ADDENDUM NO. 1

July 15, 2022

**Lawrence Township High School Site Improvements
7802 Hague Road, Indianapolis, IN 46256
7300 E. 56th St., Indianapolis, IN 46226**

PREPARED BY SCHMIDT ASSOCIATES FOR:
LAWRENCE NORTH AND LAWRENCE CENTRAL ATHLETIC FIELDS
LAWRENCE TOWNSHIP, M.S.D. OF

CG107.C

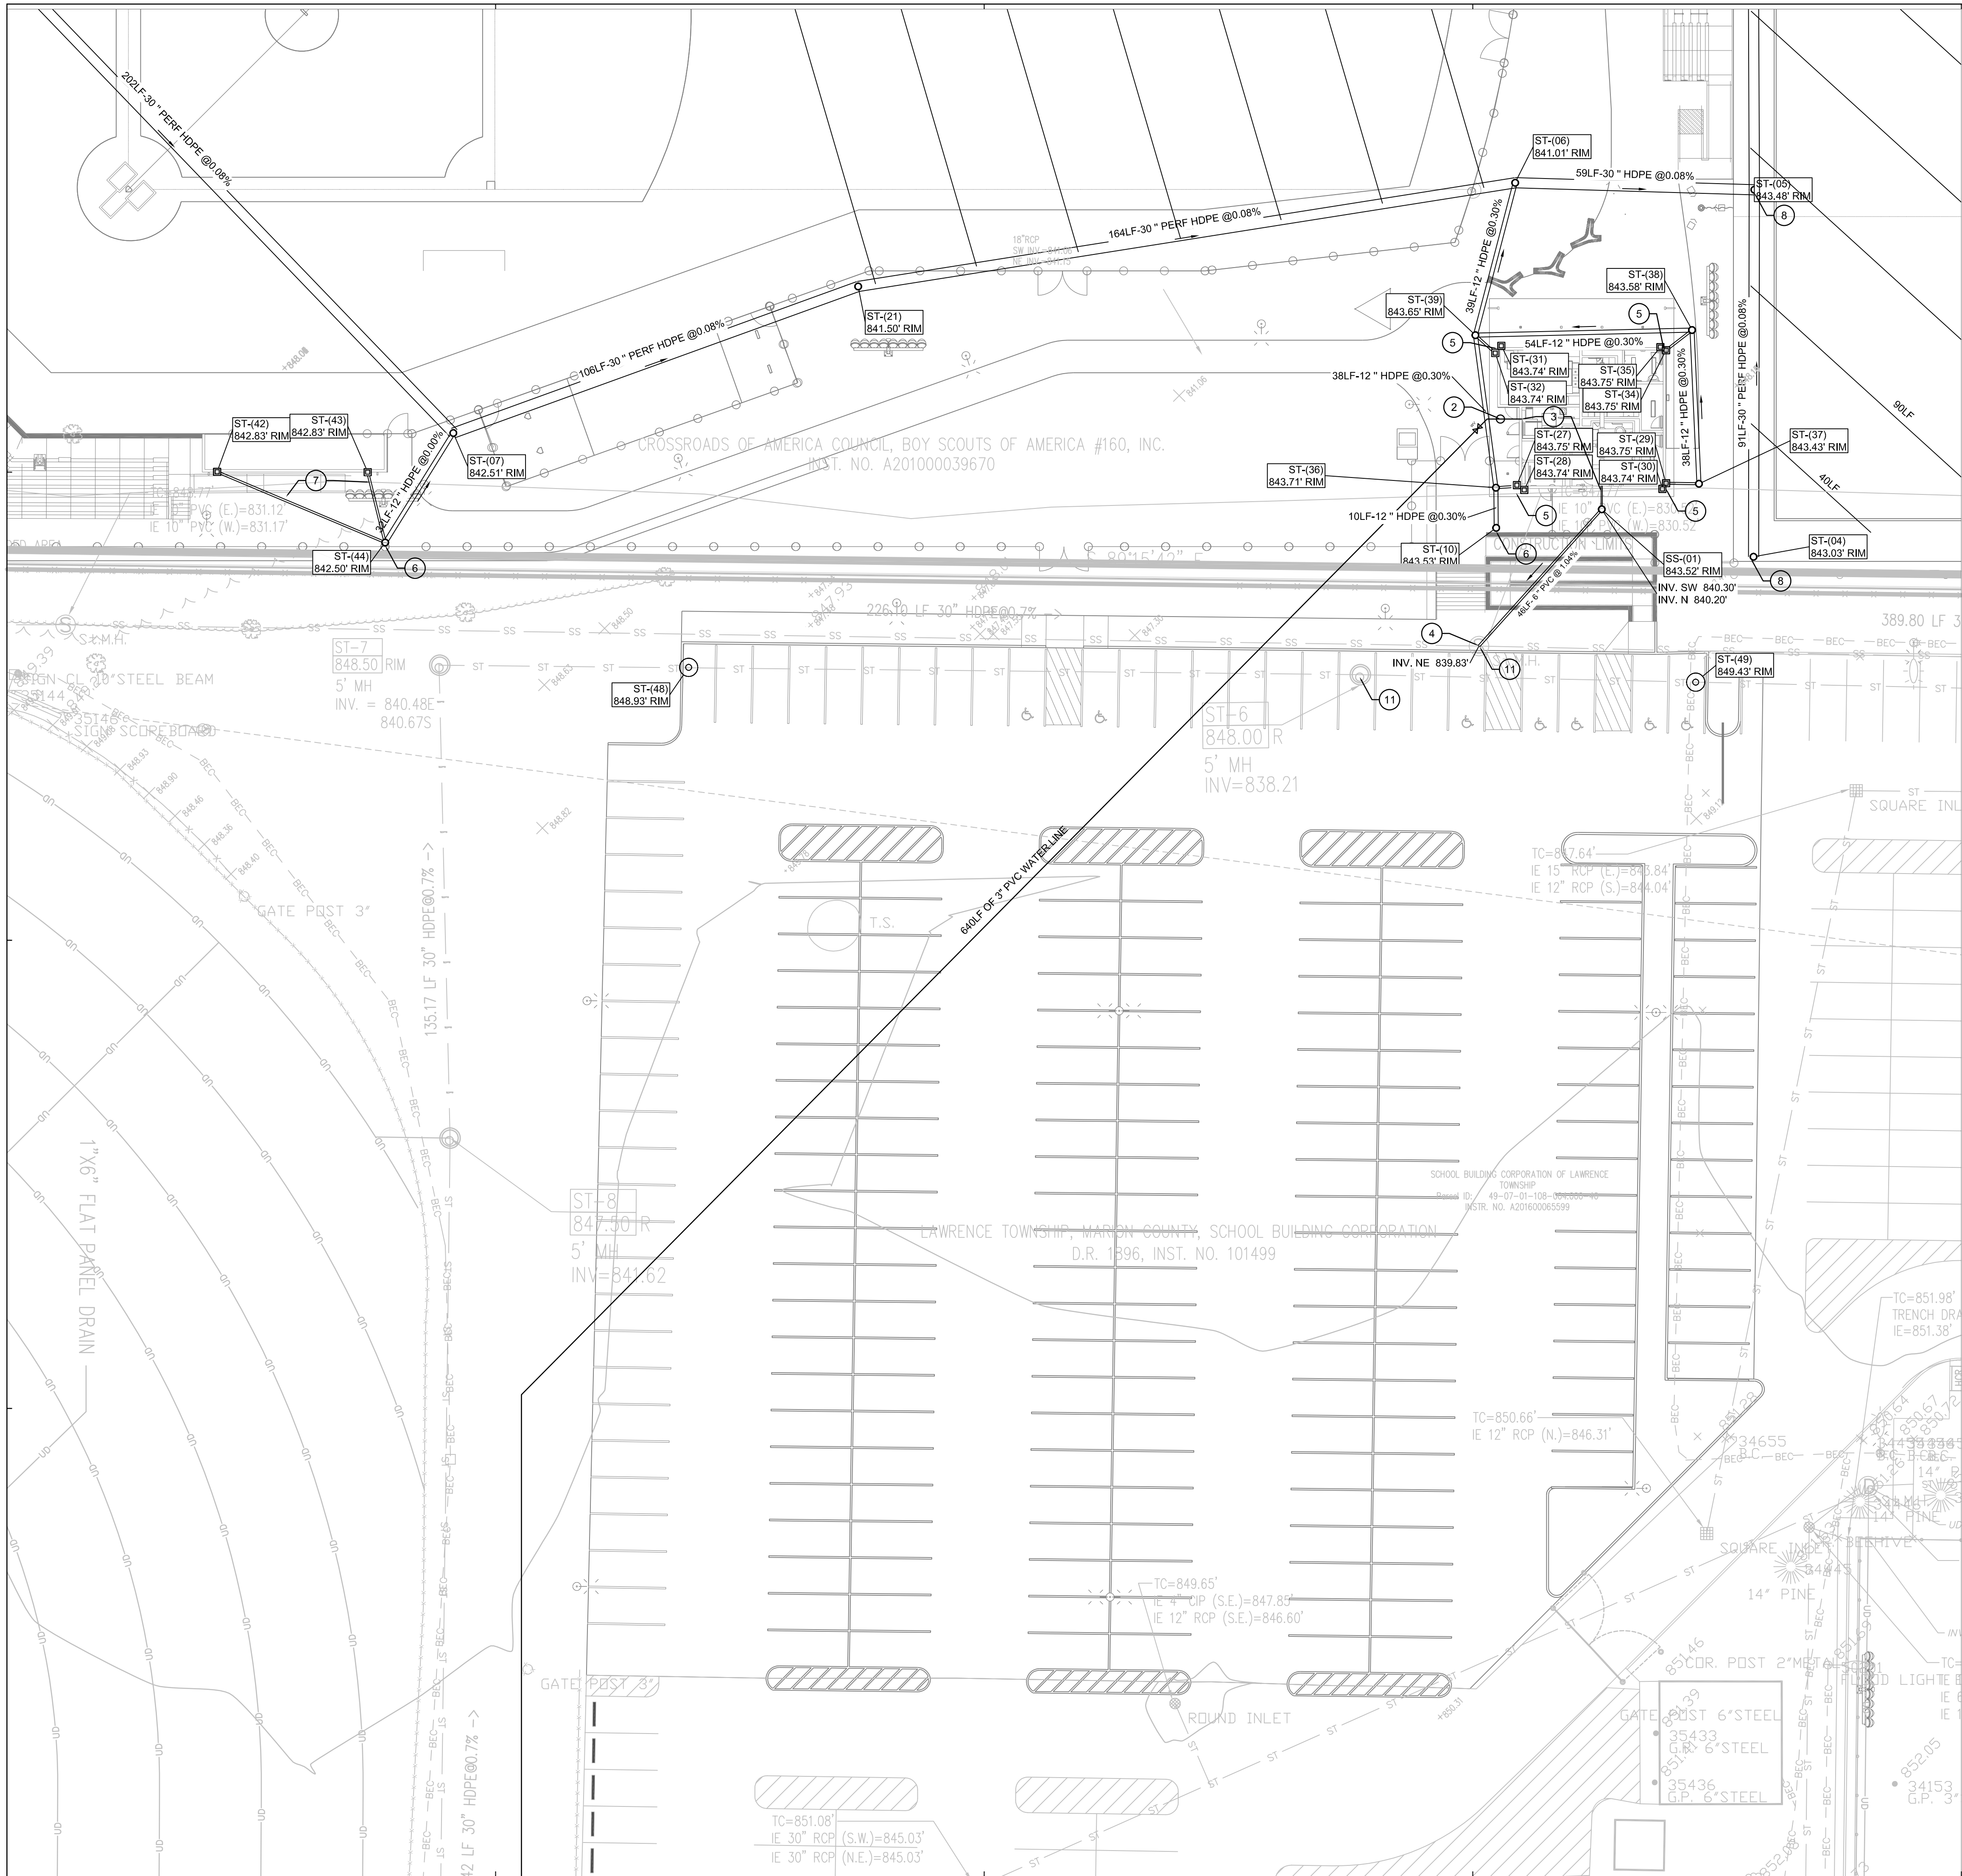
Second CG103.C	DELETE
CG107.C	ADD
Second CU104.C	DELETE
